DESIGN ADVISORY BOARD Tuesday July 12, 2016 at 3:00 PM Conference Room 12, City Hall, Burlington, VT Agenda

- 1. 16-1507CA/MA; 316-322 FLYNN AVENUE (NMU, Ward 5S) G & C Properties, LLC**
Demolish existing buildings. Construct mixed use building with 30 residential units and 2 commercial spaces and associated site improvements.
(Project Manager, Scott Gustin)

TO: Design Advisory Board
FROM: Scott Gustin
DATE: July 12, 2016
RE: 16-1507CA/MA, 316-322 Flynn Avenue

Request: Demolish existing buildings. Construct mixed use building with 30 residential units and 2 commercial spaces and associated site improvements.

Drawing Title SITE PLAN

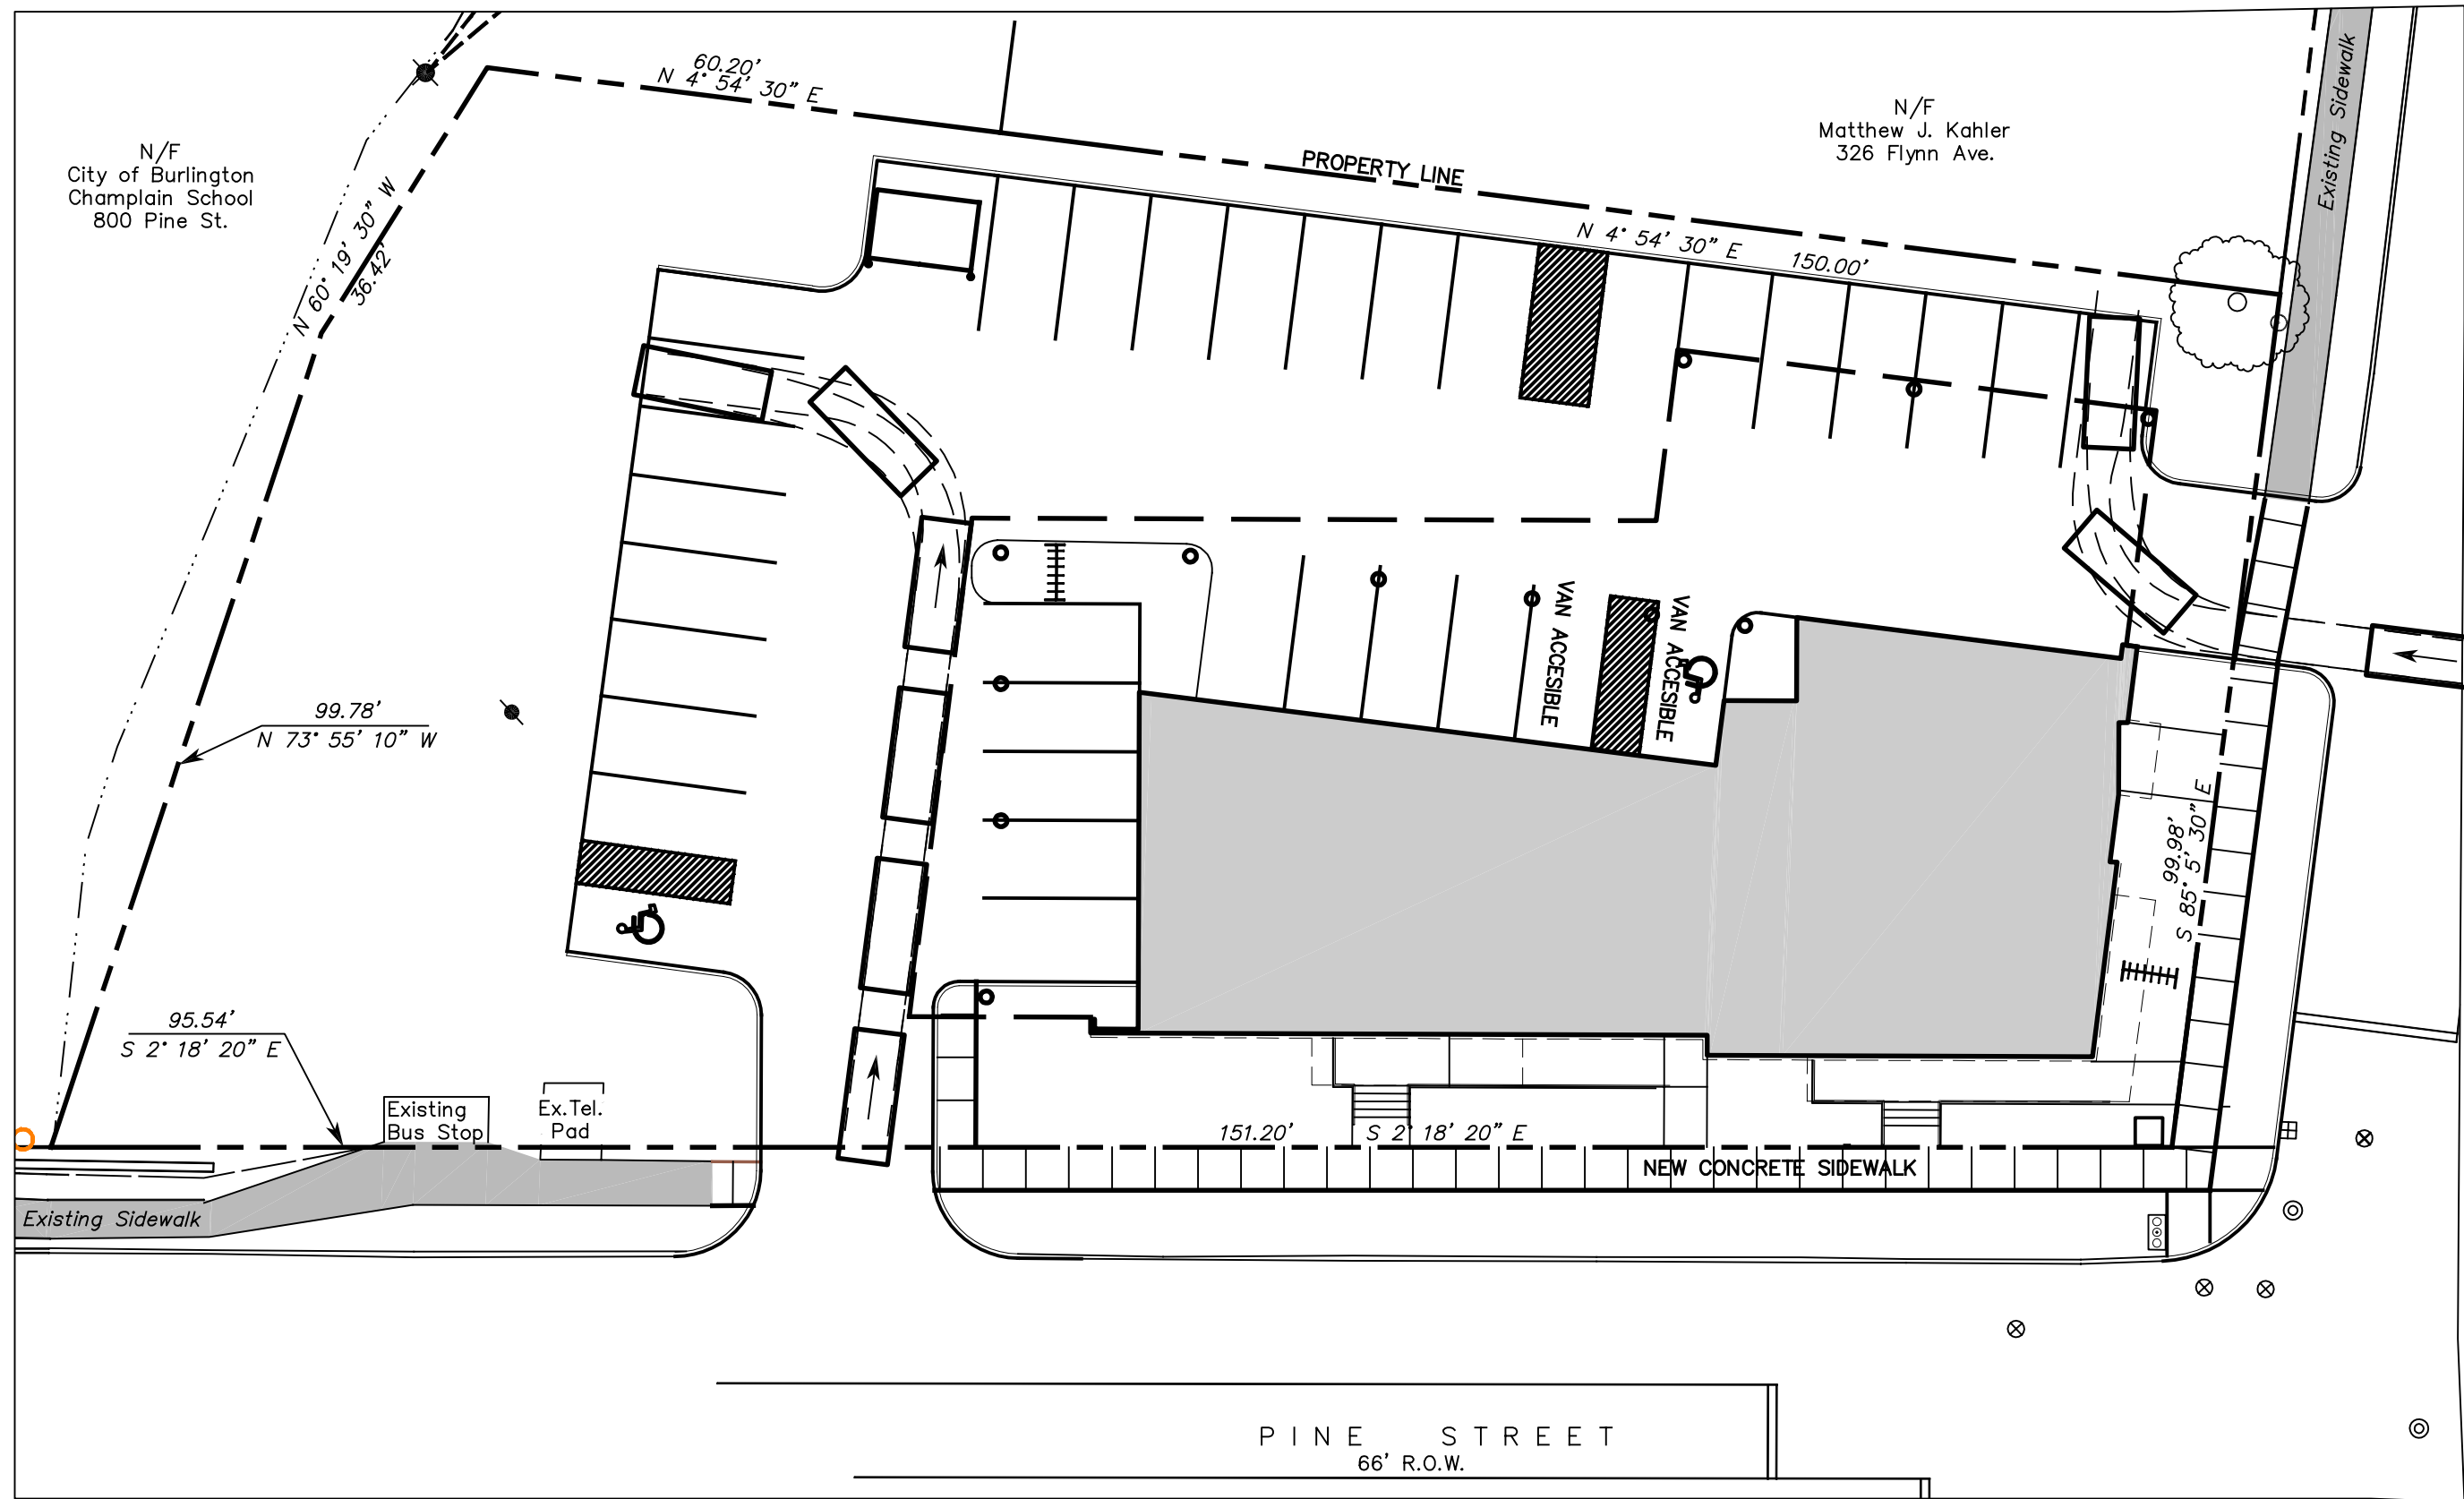
The public sidewalk along this property's street frontages will be reconstructed. Review and approval by the Department of Public Works is required. Note that the project plans show a discontinuous public sidewalk across the Pine Street driveway. The concrete sidewalk must be continued across both driveways.

Dimensionally, the parking spaces are smaller than the standard. Most of the proposed parking spaces are just 18' deep, whereas 20' is the standard. Several compact spaces are proposed at 8' width, but have 20' length. Back-up length for the 90-degree parking spaces has been improved since sketch plan to allow for 20' – 24' or more. The standard for such spaces is 24.' A site circulation plan has been provided that demonstrates the sufficiency of the proposed parking and circulation layout. A small walkway of sorts has been provided at the northeast corner of the building to afford pedestrian access from the parking area into the northeast building entry.

Exposed surface parking totals 17 spaces. Surface parking areas of 15 or more spaces require at least 1 shade tree for every 5 parking spaces. Those shade trees are not evident in the project plans and must be provided. The shade trees must be 2.5" – 3" caliper at planting with an expected mature canopy of at least 25' diameter. At least 30% of the surface parking should be shaded. No shading analysis has been provided and must be.

1. The concrete public sidewalk must be continued across both driveways.
2. Shade trees are required – 1 for every 5 surface parking space (3 trees in this case). At least 30% shading of the surface parking and circulation should be achieved. A shading plan must be provided.
3. New street trees are subject to review and approval by the City Arborist.
4. Building entry lighting levels must be included in the photometric plan.
5. The dumpster must be placed on a concrete pad.

PLANTING PLAN

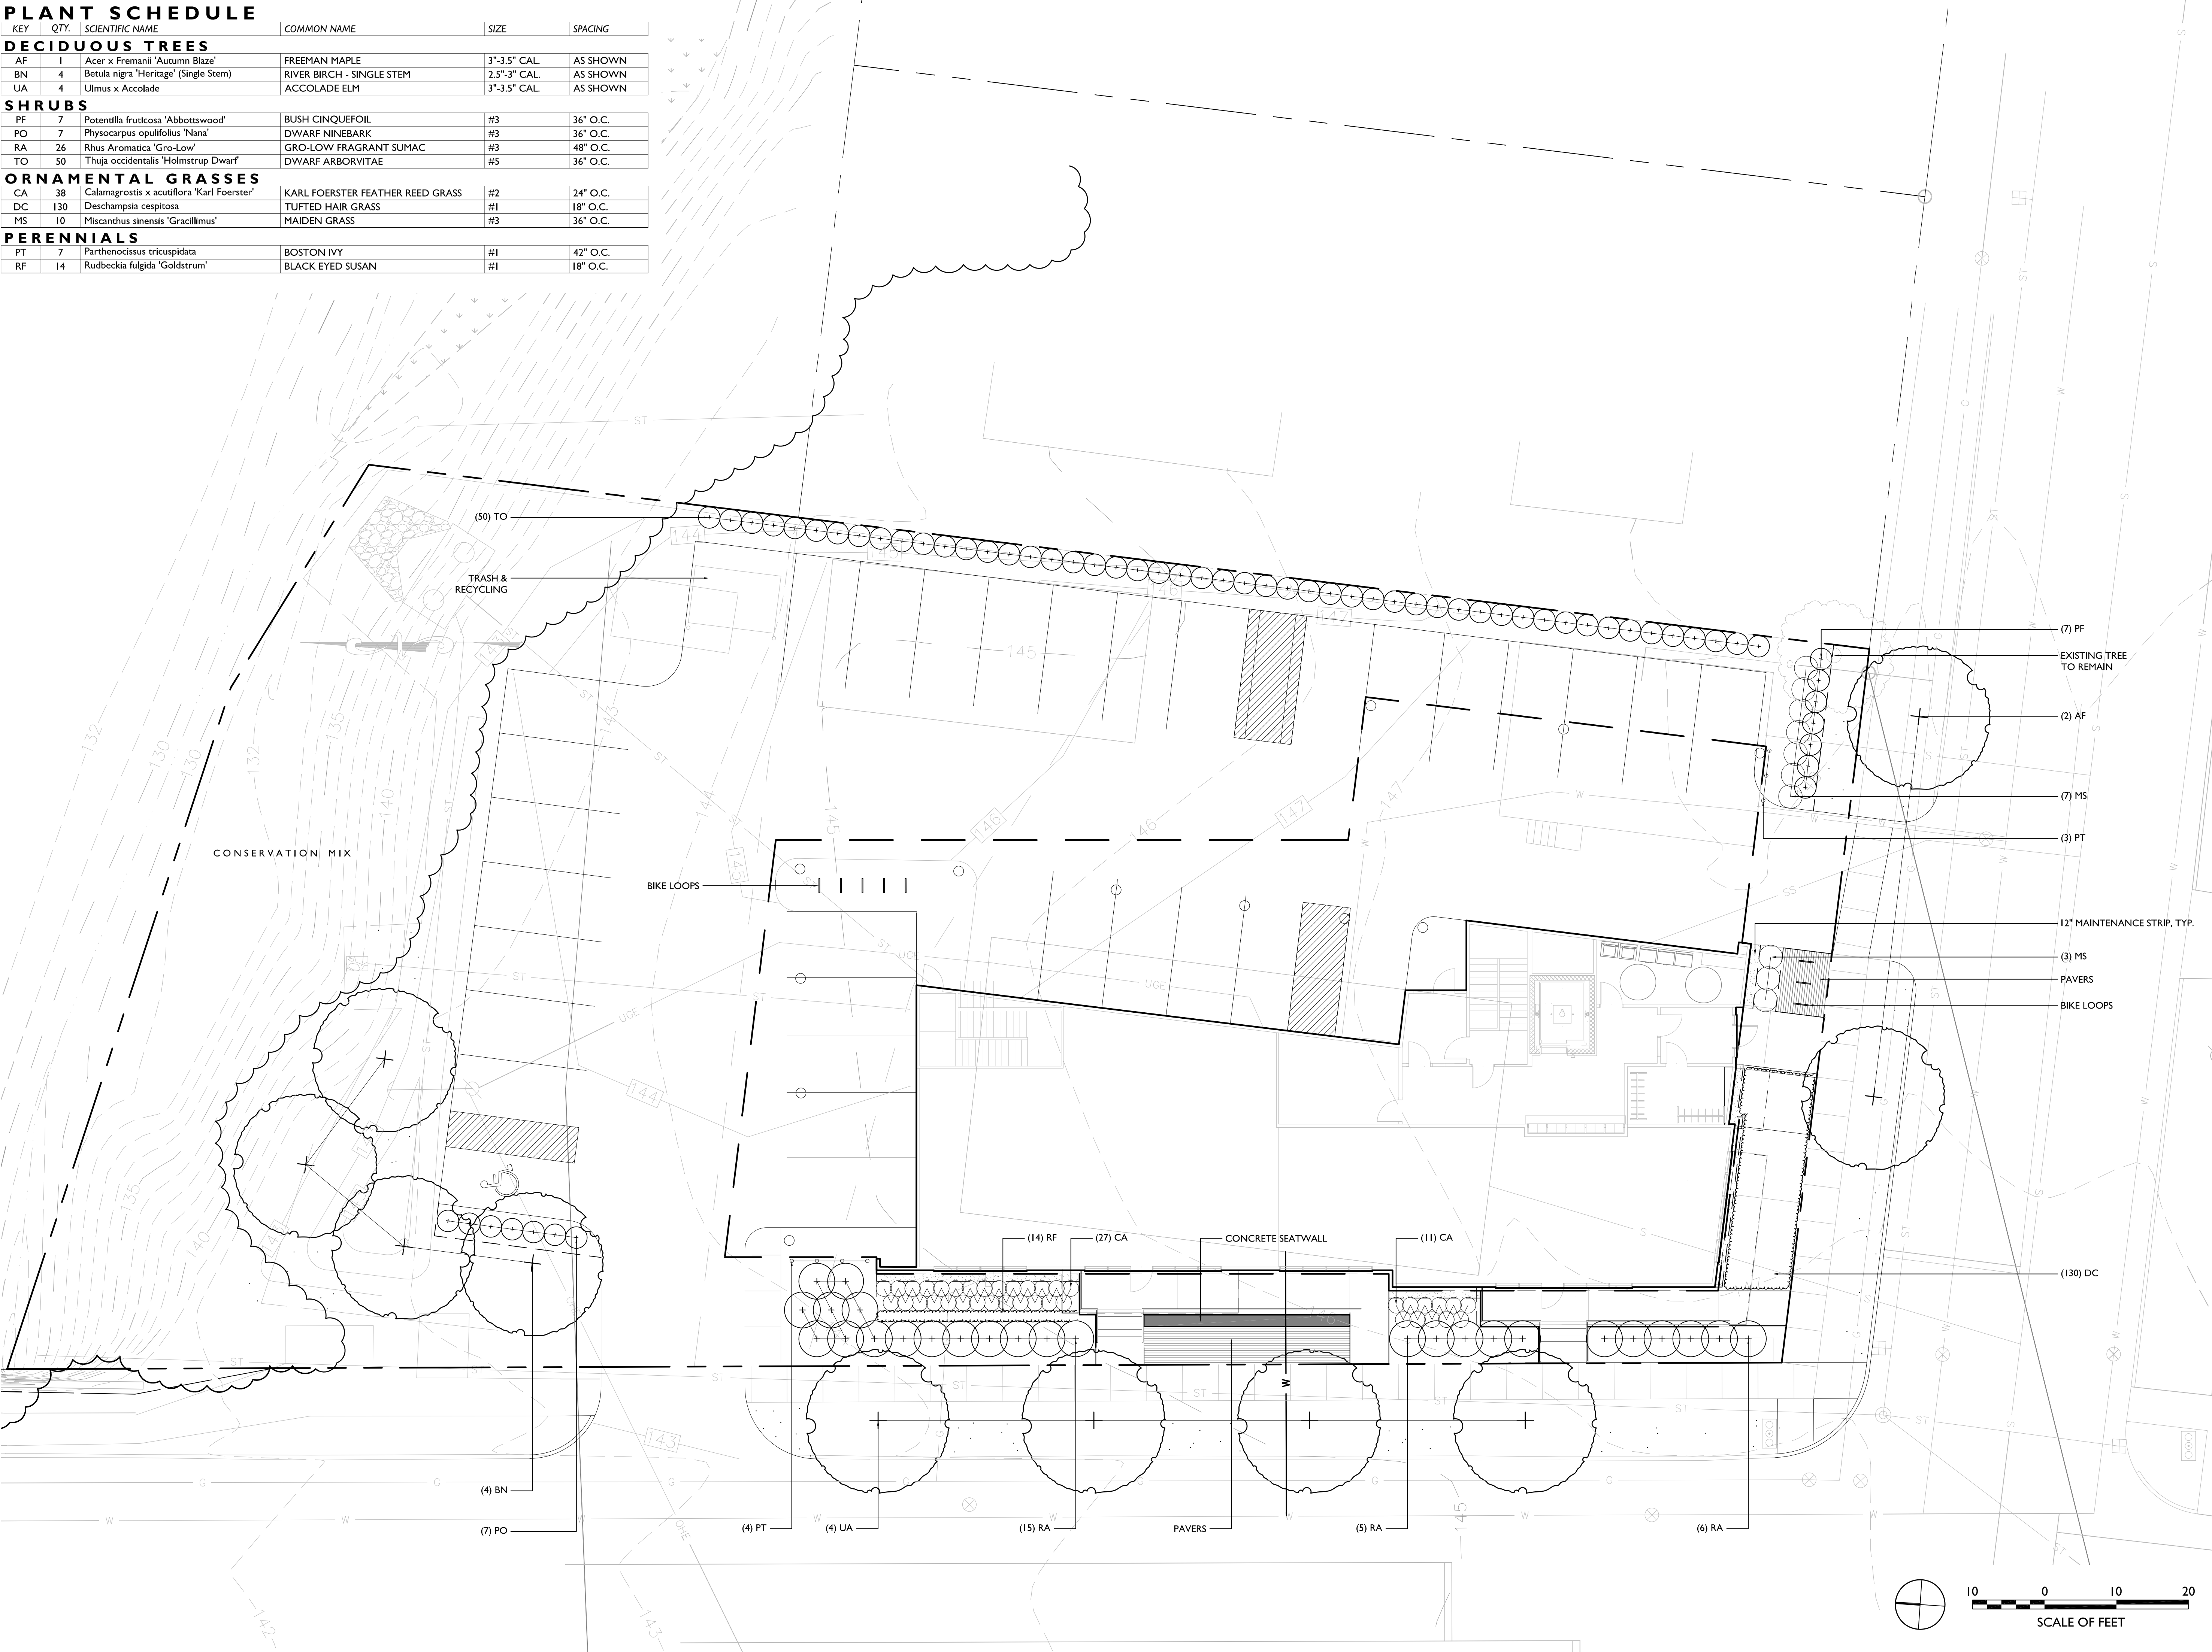
A planting plan has been provided. New plantings will help to screen surface parking from the street and neighboring property. It will also be used to enhance the property's visual appeal along its street frontages. Note that several new street trees are proposed. They will require the review and approval of the City Arborist.
